SUBJECT: Council Agenda Responses

DATE: October 2, 2017

C-1 - An Ordinance to Amend Chapter 55 (Zoning), Zoning of 6.4 Acres from PUD (Planned Unit Development) to C1A/R (Campus Business Residential District) WITH CONDITIONS, 1140 Broadway Rezoning, (CPC Recommendation: Approval - 6 Years and 1 Nays)

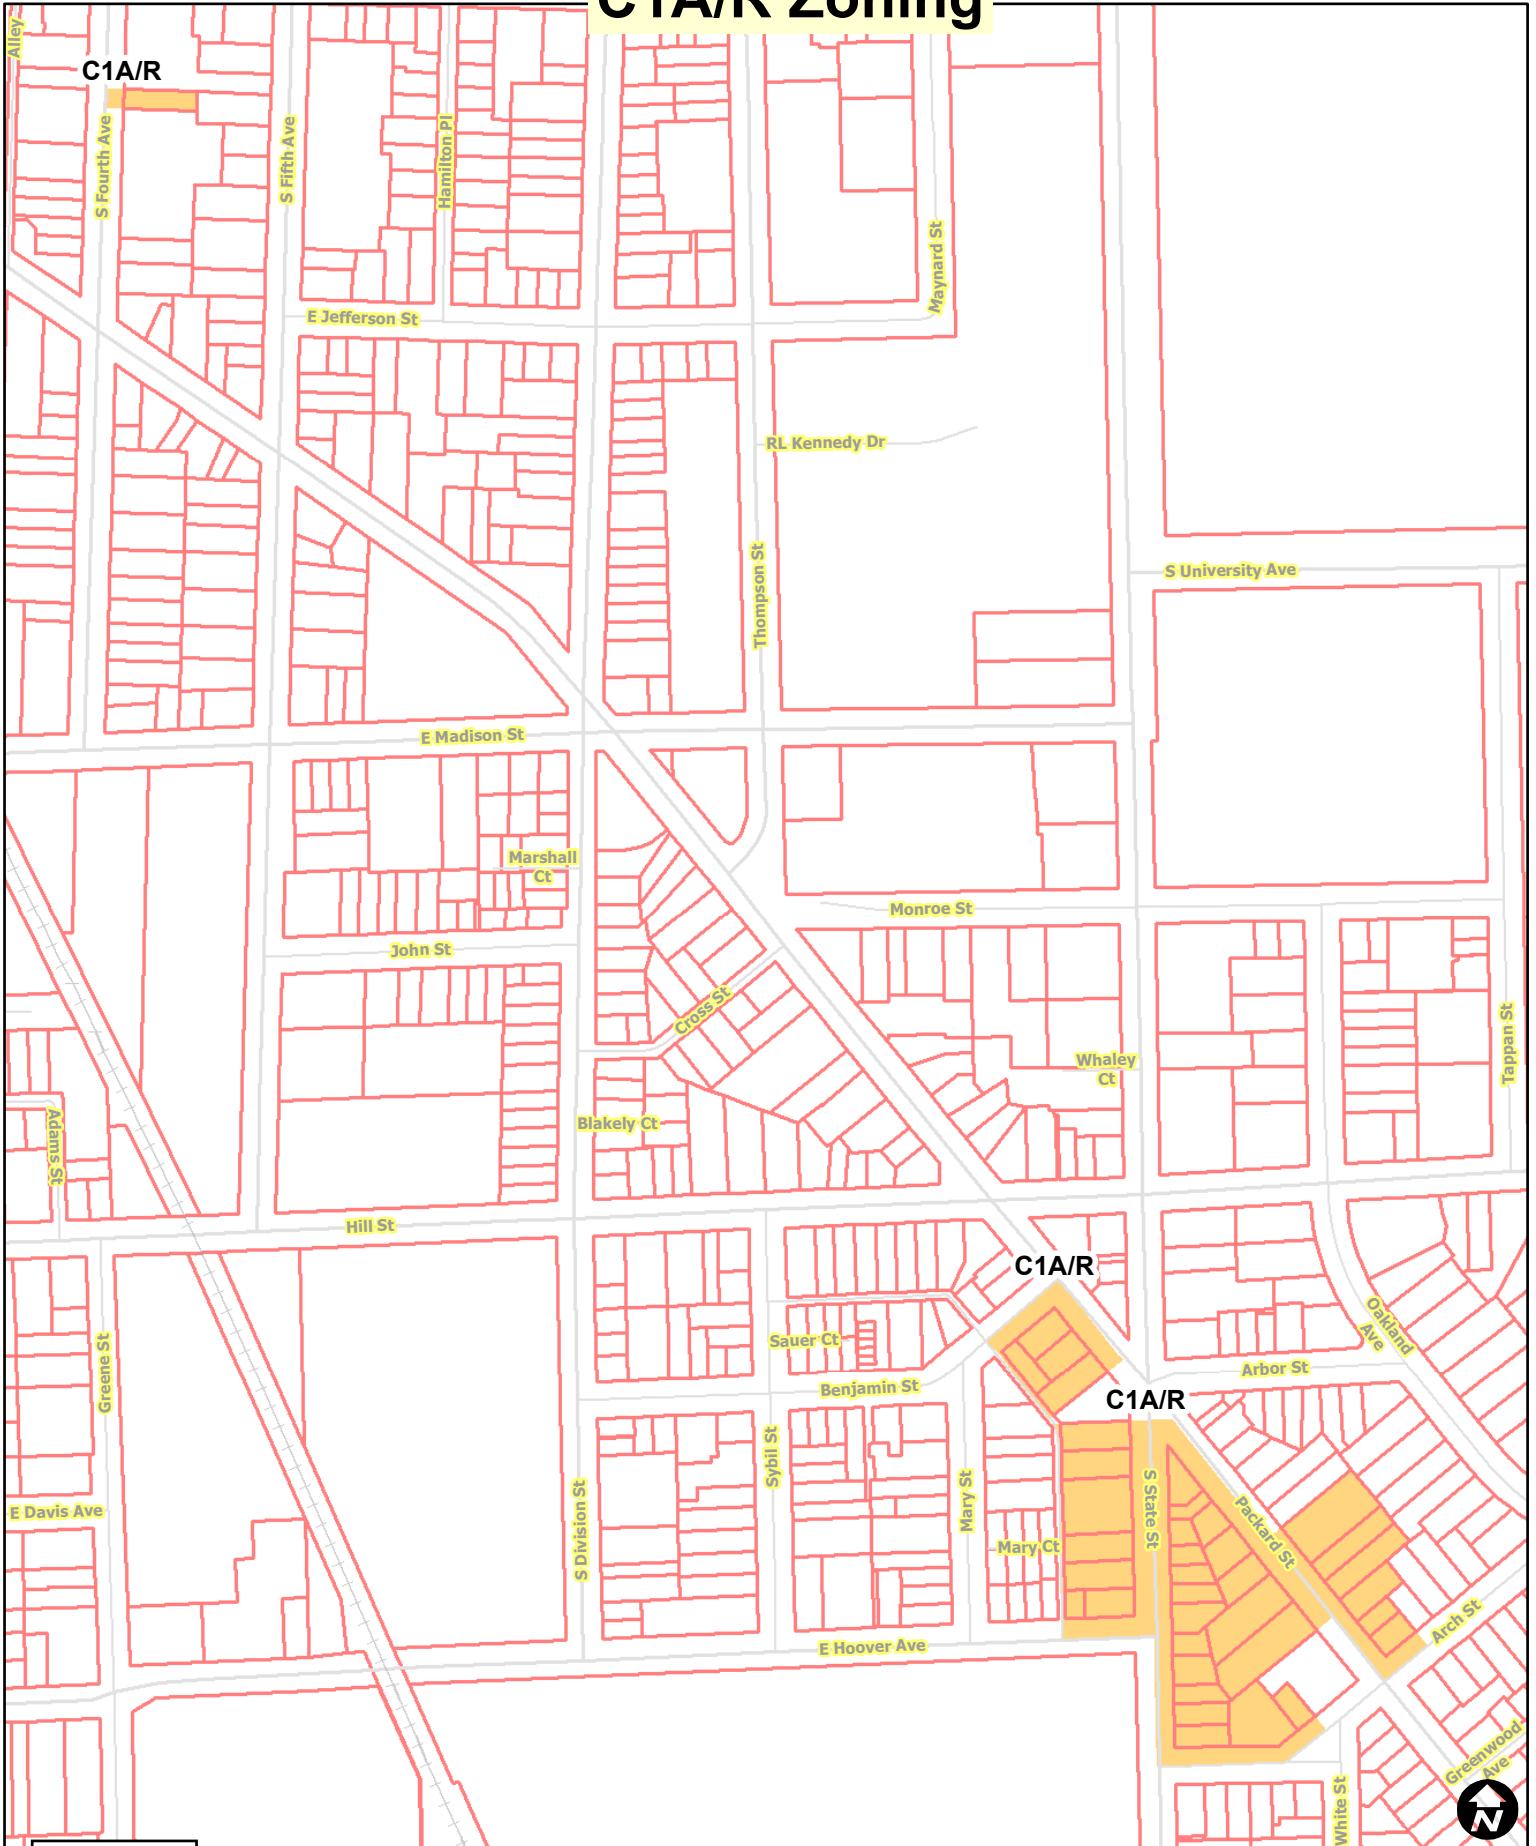
Question: Q5. I can't recall considering any other proposals with this C1A/R zoning. Can you please provide a map, chart or something that shows where the C1A/R parcels are located? Also, it would seem to me that zoning would be for parcels very close to campus and while the hospital is not all that far, the property is not next to campus so can you please explain why this zoning is appropriate? (Councilmember Lumm)

Response: A map is attached that shows other C1A/R parcels in the City. The Planning Commission recommended approval as the FAR requirements and mixed-use nature of the C1A/R are compatible with creating a mixed-use urban village form of development.
